Evenflo Company, Inc.
3131 Newmark Drive, Suite 300
Miamisburg, Ohio 45342
United States

August 15, 2022

RE: Evenflo Company, Inc. – Petition for Reconsideration
49 CFR Part 571
Docket No. NHTSA-2022-0051
RIN 2127-AK95
Federal Motor Vehicle Safety Standards; Child Restraint Systems,
Child Restraint Systems—Side Impact Protection

Examples of underlying structures with exposed radii less than 6 mm.

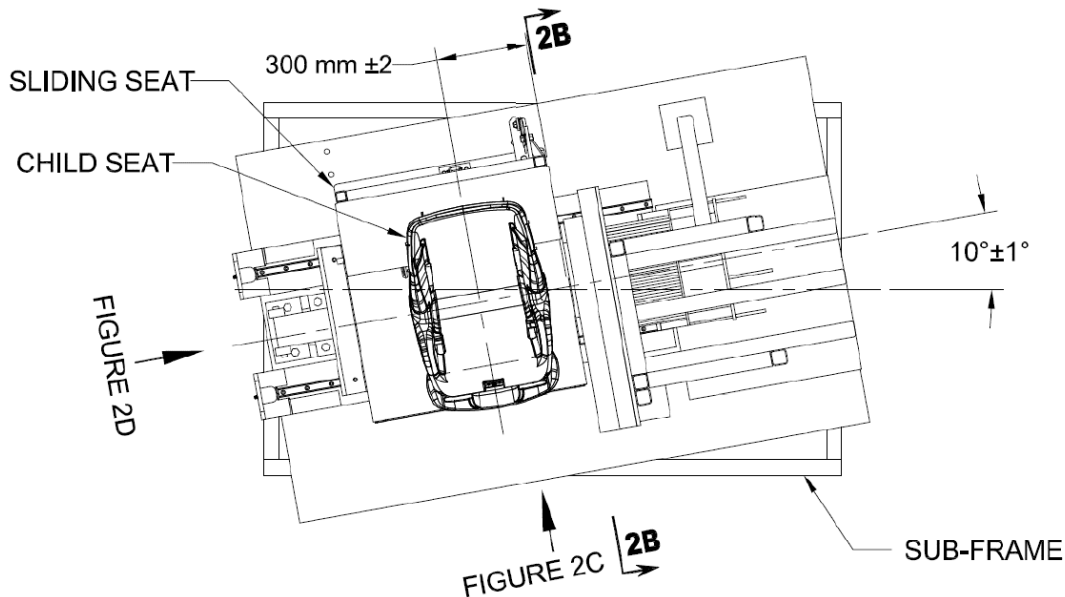
4. *S5.4.1 Protrusion Limitation. (a) Any portion of a rigid structural component within or underlying a contactable surface shall, with any padding or other flexible overlay material removed, have a height above any immediately adjacent restraint system surface of not more than 9 millimeters and no exposed edge with a radius of less than 6 millimeters.*

Clarification Requested:

It is Evenflo's understanding that NHTSA tentatively determined that adding energy-absorbing padding to the CRS around the head area of the child and to the side structures

(CRS side “wings”) would likely be sufficient for CRSs to meet the proposed requirements¹. In fact, many child restraints have energy-absorbing materials adhered to the side wings. Many modern seats (available in the market since 2018) have structures underneath these energy-absorbing materials that would not comply with exposed edge radius requirement prior to testing if the energy-absorbing materials were removed. NHTSA theorized without evidence, “[p]adding will compress in an impact and the load on the child would be concentrated and potentially dangerous.”² However, if the integrated energy absorbing materials are treated as part of the rigid structural component, a child occupant will not contact the edge because the energy absorbing material covering the underlying structure will prevent any contact even as the energy absorbing materials are compressed. As noted above, Evenflo requests clarification of definition the contactable surface, especially as it pertains to the interplay between padding/other flexible overlay material and the rigid components underneath those materials. For example, are the energy absorbing materials integrated to the system structures considered padding and flexible overlay materials? Will they be removed? If the energy absorbing materials are attached with mechanical fasteners (push pins, tape or glue, etc.) are they considered padding or part of the structure to be evaluated for the protrusion limitations?
